Intel[®] StrongARM[®] SA-1100 Microprocessor

Specification Update

February 2000

Order Number: [278105-025](#)

14. SA-1100 Functional Diagram: Figure 2-2

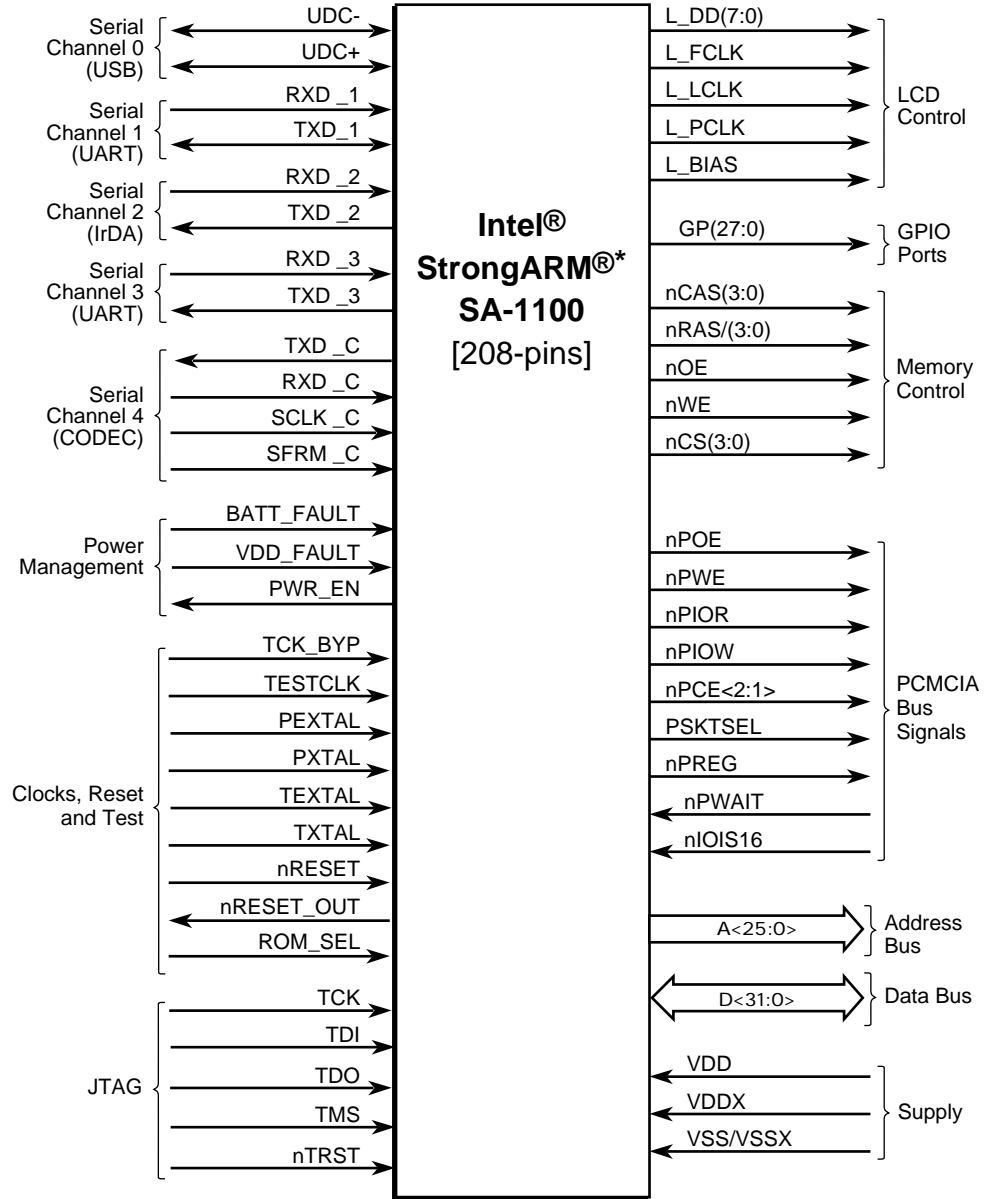
Changed label for Serial Channel 1.

20. DRAM Timing: Section 10.3.2

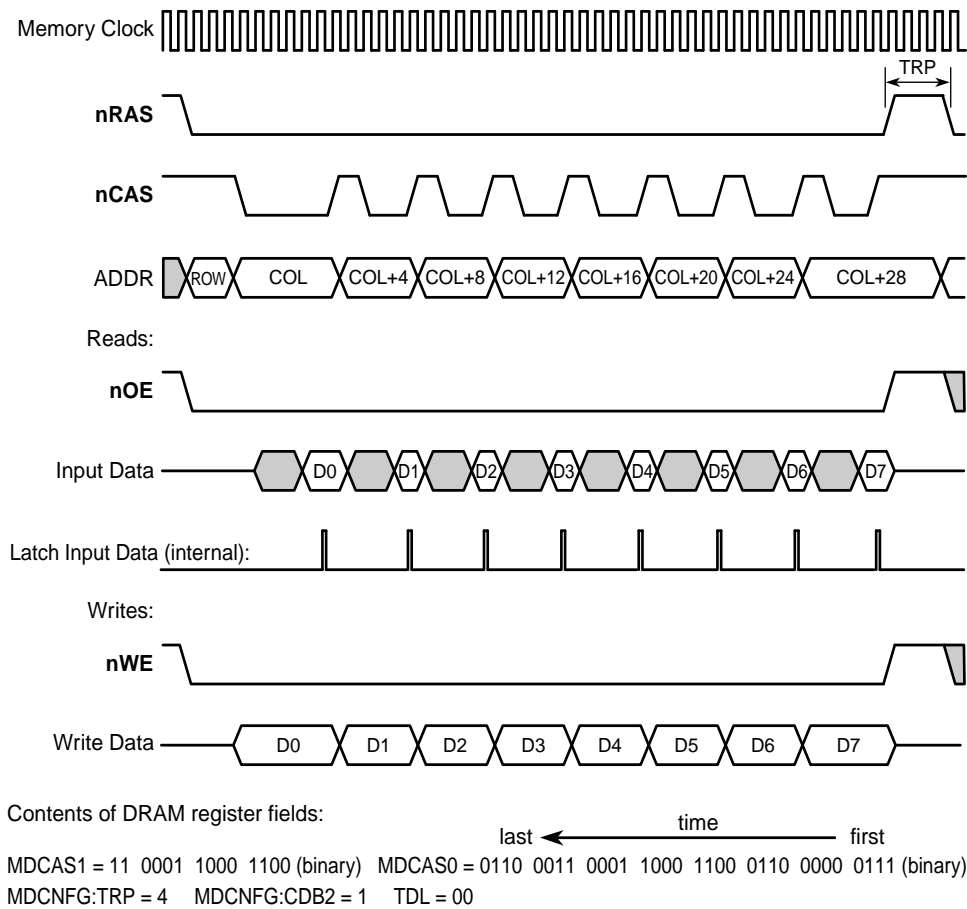
Update Figure 10-4 as shown below.

21. DRAM Refresh: Section 10.3.3

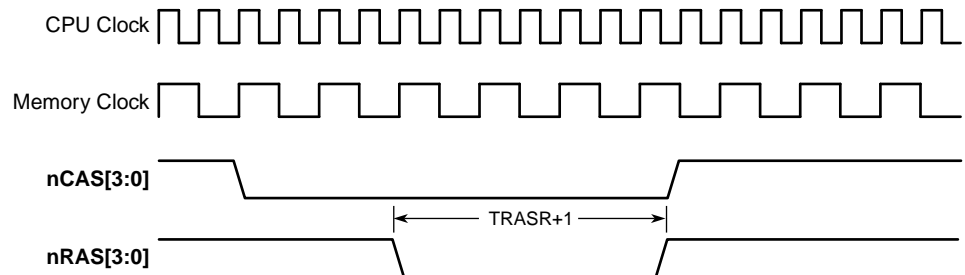
Update Figure 10-5 as shown below.

SRAM Timing Diagrams and Parameters: Section 10.4.4

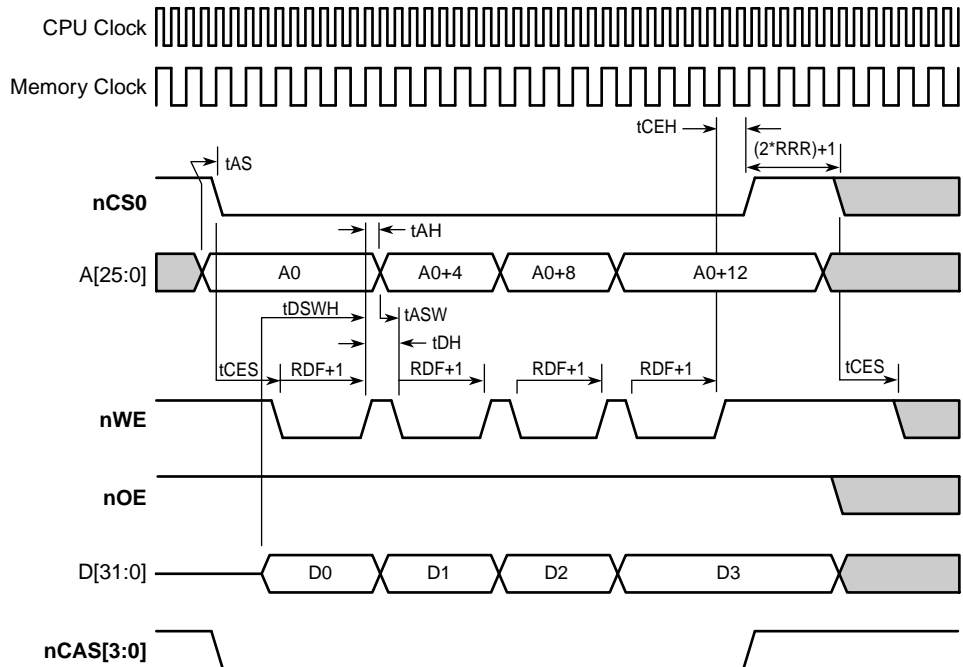
Update Figure 10-9 as shown below.

Changed the “tDSWH = Write data setup to nWE high (deasserted) = 1/2 memory cycle + (RDN+1) memory cycles” line in the parameters list (following the figure) to:

“:tDSWH = Write data setup to nWE high (deasserted) = 1/2 memory cycle + (RDF+1) memory cycles”

24. FLASH EPROM Timing Diagrams and Parameters: Section 10.4.6

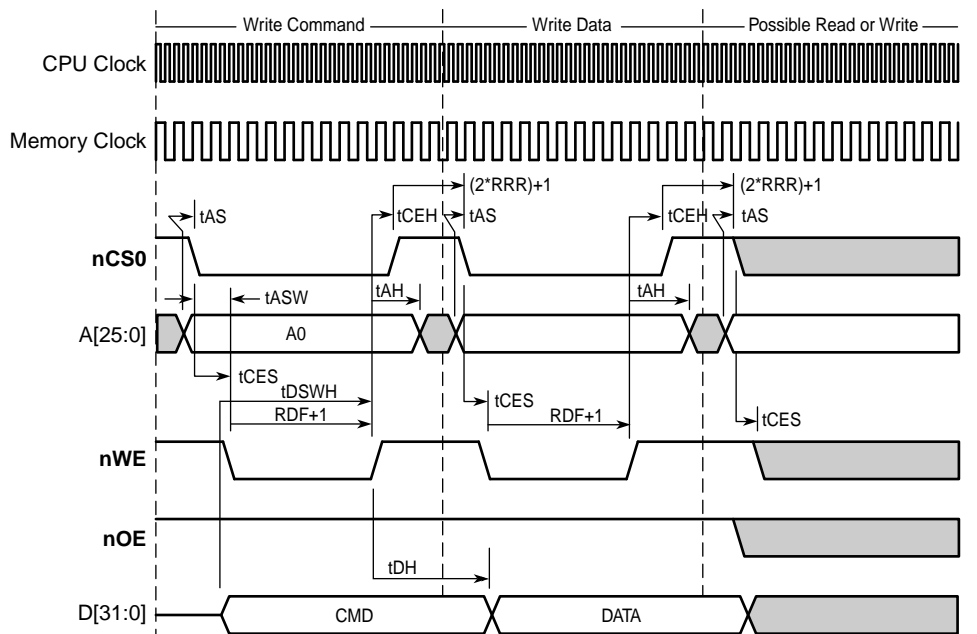
Update Figure 10-10 as shown below.

Changed the “ $t_{DSWH} = \text{Write data setup to nWE high (deasserted)} = 1/2 \text{ memory cycle} + (\text{RDN}+1) \text{ memory cycles}$ ” line in the parameters list (following the figure) to:

“ $t_{DSWH} = \text{Write data setup to nWE high (deasserted)} = 1/2 \text{ memory cycle} + (\text{RDF}+1) \text{ memory cycles}$ ”
